Access Compliance Report

Public Rights-of-Way

(Curb Ramps)

Intersection ID: 31707	Main Street: ATLAS_CEDAR_DR	Cross Street: WEEPING_FIG_LN	Location: W
ADA ID: 4B5EF41693F7	Ramp Type: Perp	Initial Pass/Fail: Fail	Overall Compliance: No
Severity Score: 8.75			
Codes/Mitigation Info/Possible Solution		Field Measurements/Component Compliance

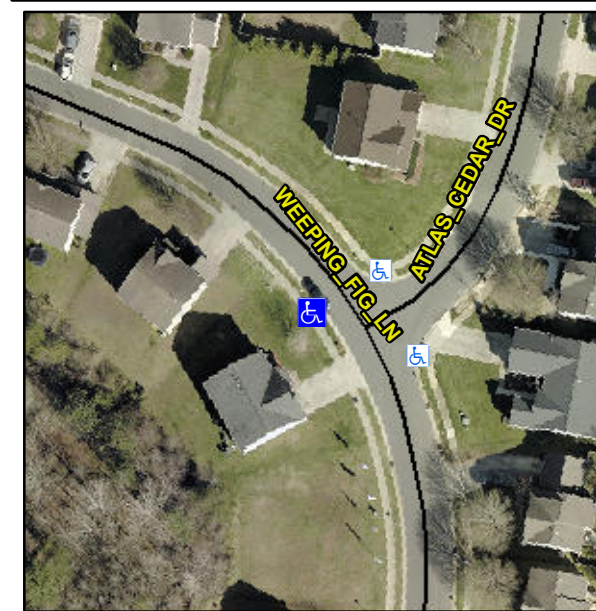
Not Found, R304.5.1

Compliance	Description	Data	Compliance	Description	Data
N/A	Ramp Length (in)	47.5	Yes	Ramp Slope (%)	5.1
No	Ramp Width (in)	47.0	Yes	Ramp XSlope (%)	0.4
N/A	Flare Type LT	N/A	N/A	Flare Type RT	N/A
N/A	Flare Slope LT (%)	N/A	N/A	Flare Slope RT (%)	N/A
N/A	Flare Traversable LT?	N/A	N/A	Flare Traversable RT?	N/A
N/A	Landing Length (in)	N/A	N/A	DWS Provided?	N/A
N/A	Landing Width (in)	N/A	N/A	DWS Contrast?	N/A
N/A	Landing Slope (%)	N/A	N/A	DWS Length (in)	N/A
N/A	Landing X Slope (%)	N/A	N/A	DWS Full Width?	N/A
N/A	Landing Curb? (Y/N)	N/A	N/A	DWS Offset (in)	N/A
N/A	Shared Landing?	N/A			
N/A	Gutter Ponding?	N/A	N/A	Gutter Slope (%)	N/A
N/A	Gutter Lip Ht (in)	N/A	N/A	Gutter X Slope (%)	N/A
N/A	Painted X Walk1?	No	N/A	Painted X Walk2?	N/A
	X Walk 1 Direction	To E		X Walk 2 Direction	N/A
N/A	X Walk 1 Width (in)	N/A	N/A	X Walk 2 Width (in)	N/A
	X Walk 1 Slope (%)	2.7		X Walk 2 Slope (%)	N/A
	X Walk 1 X Slope (%)	2.0		X Walk 2 X Slope (%)	N/A

Remove & Replace Entire Ramp.
